SUBJECT: Morris Municipal James R. Washburn Field Airport
Morris, Illinois
Grundy County
Illinois Project Number: C09-4442
SBG Project Number: 3-17-SBGP-120
Contract No. MR022
Item No. 08A, January 19, 2018 Letting
Addendum A

NOTICE TO PROSPECTIVE BIDDERS

This addendum removes the requirement for the PAPI equipment to only be a LED light source system.

The Construction Safety Plan (Sheet 3) has also been updated.

CONSTRUCTION SAFETY PLAN

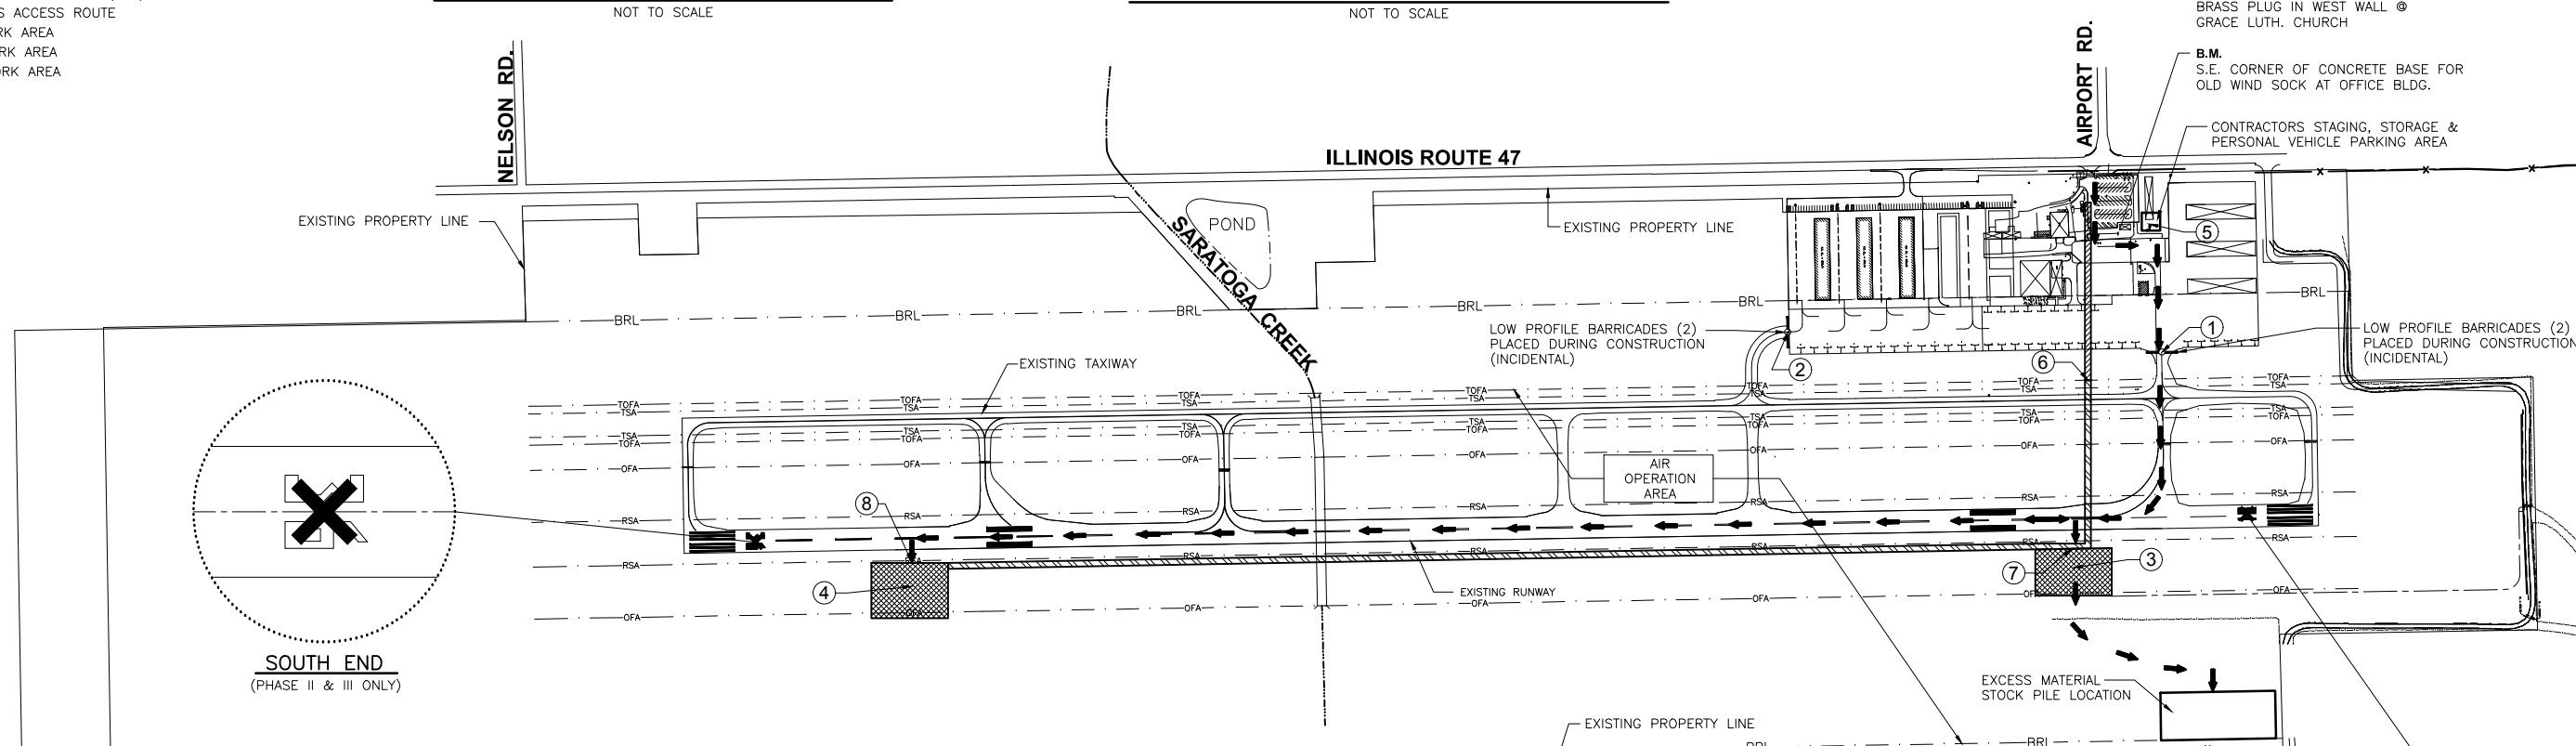
1. Replace the Construction Safety Plan (Sheet 3) with the attached Revised Construction Safety Plan.
2. Replace the ITEM AR125615 PAPI (L-880 System) special provision (pages 27-34) with the attached revised ITEM AR125615 PAPI (L-880 System) special provision.
